<b>Title - Sujet</b> Additional Fridge & Freezer Space	
<b>Solicitation No. - N° de l'invitation</b> EZ899-162042/A	<b>Amendment No. - N° modif.</b> 003
<b>Client Reference No. - N° de référence du client</b>	<b>Date</b> 2016-02-19
<b>GETS Reference No. - N° de référence de SEAG</b> PW-\$PWY-025-7732	
<b>File No. - N° de dossier</b> PWY-5-38359 (025)	<b>CCC No./N° CCC - FMS No./N° VME</b>
<b>Solicitation Closes - L'invitation prend fin</b> <b>at - à 02:00 PM</b> <b>on - le 2016-02-23</b>	<b>Time Zone</b> <b>Fuseau horaire</b> Pacific Standard Time PST
<b>F.O.B. - F.A.B.</b> <b>Plant-Usine:</b> <input type="checkbox"/> <b>Destination:</b> <input checked="" type="checkbox"/> <b>Other-Autre:</b> <input type="checkbox"/>	
<b>Address Enquiries to: - Adresser toutes questions à:</b> Fung, Donna(PWY)	<b>Buyer Id - Id de l'acheteur</b> pwy025
<b>Telephone No. - N° de téléphone</b> (604) 666-9835 ( )	<b>FAX No. - N° de FAX</b> (604) 775-6633

This Amendment No. 003 is raised to incorporate Addendum #2.

**CORRECTIONAL SERVICES CANADA  
ADDITION OF FREEZER AT MATSQUI  
INSTITUTION**

## **PHOTOGRAPH OF EXISTING FENCE**

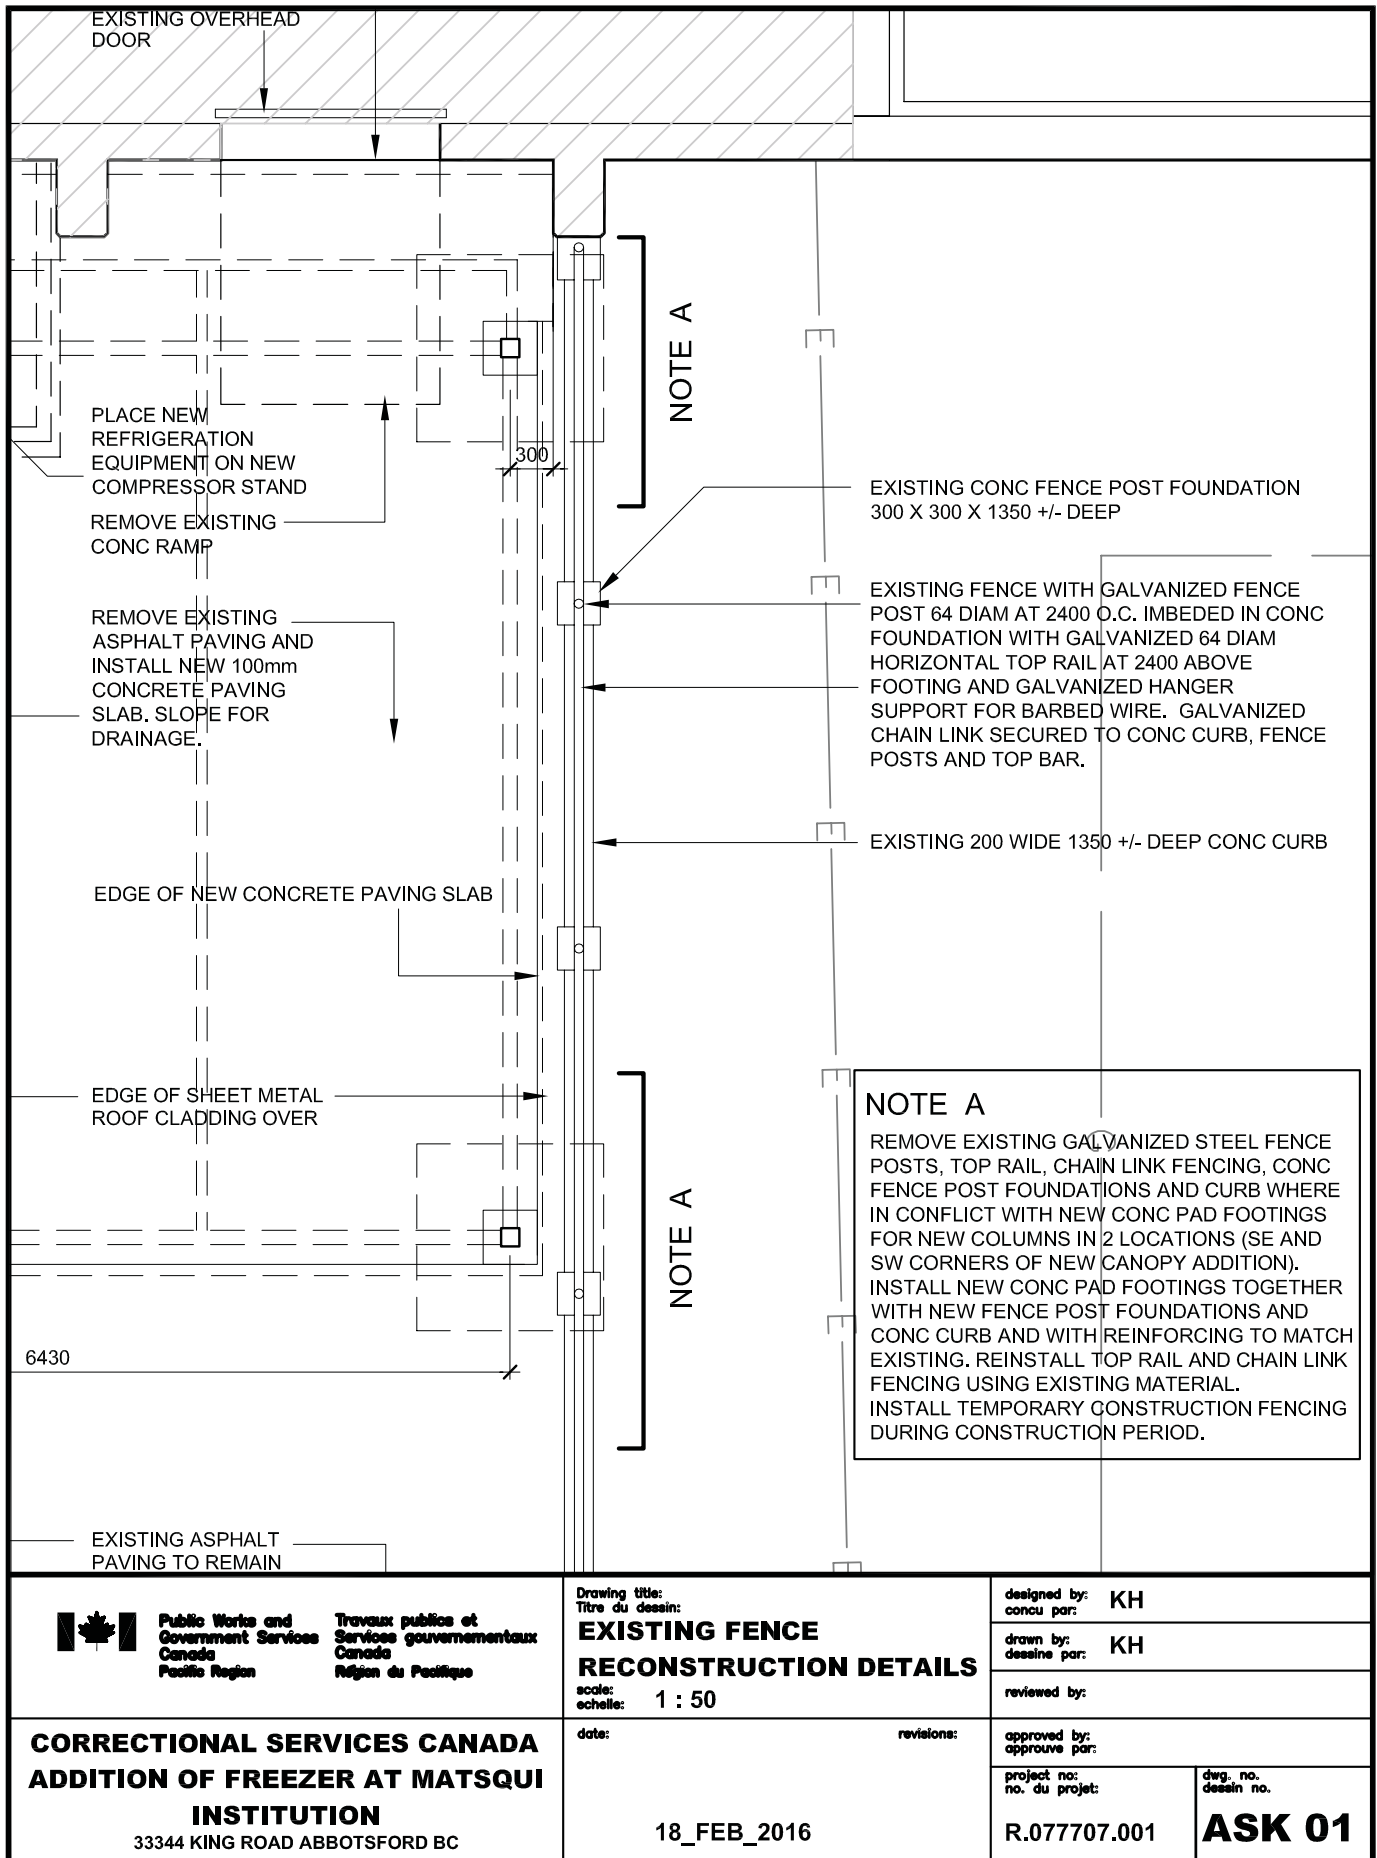
- .1 Contractor shall familiarize themselves with relevant conditions of existing building at the time of Tender. Photograph of existing fence attached for reference.
